APICAL INDUSTRIES, INC.
dba DART AEROSPACE

ENGINEERING CHANGE NOTICE NO.

DWG NO. 647.7700

DWG TITLE: STRUT ASSY

SHEET 2, ZONE D4 IS:

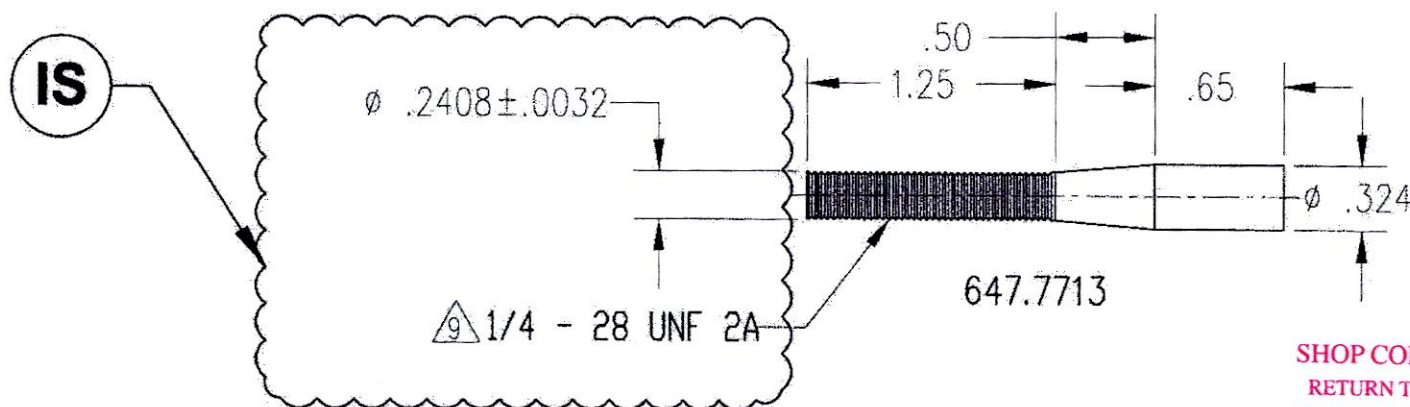
REASON: REVISED DIMENSION

1.

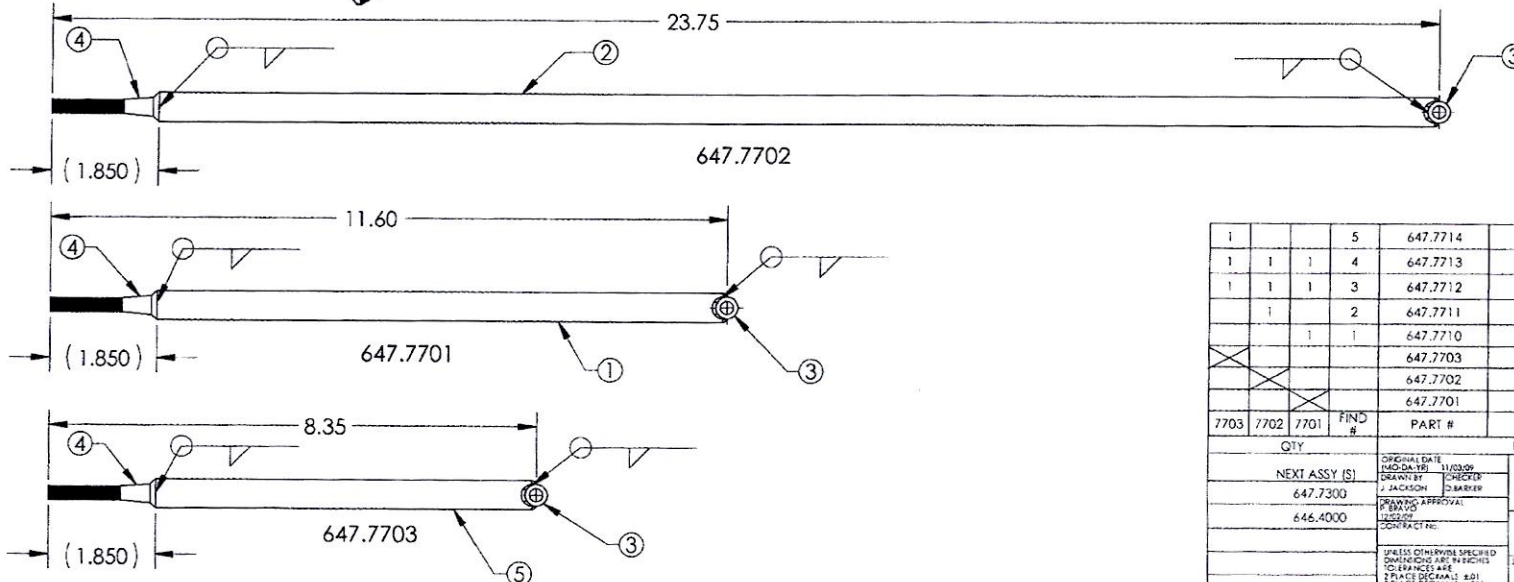
REASON: REVISED FINISH CALLOUT AS PER ECR 15-209

SHEET 1, NOTES IS:

- 1 MATERIAL: 4130 STEEL PER AMS-T-6736, .50" OD, .083" WALL THK.
- 2 MATERIAL: 4130 STEEL PER AMS-T-6736, .375" OD, .075" WALL THK.
- 3 MATERIAL: 4130 STEEL PER AMS-T-6736, .324" OD.
- 4 FINISH: PRIME IAW MIL-P-2337J TYPE I CLASS N; 1-2 MIL MAX
5. DEBURR AND BREAK ALL SHARP EDGES
6. IDENTIFY IAW MPP-120.
- 7 WELD IAW MIL-STD-2219. TIG WELD WITH FILLER ROD
- 8 FINISH: CAD PLATE IAW QQ-P-416F CLASS I TYPE II
- 9 MASK THREAD PRIOR TO FINISH
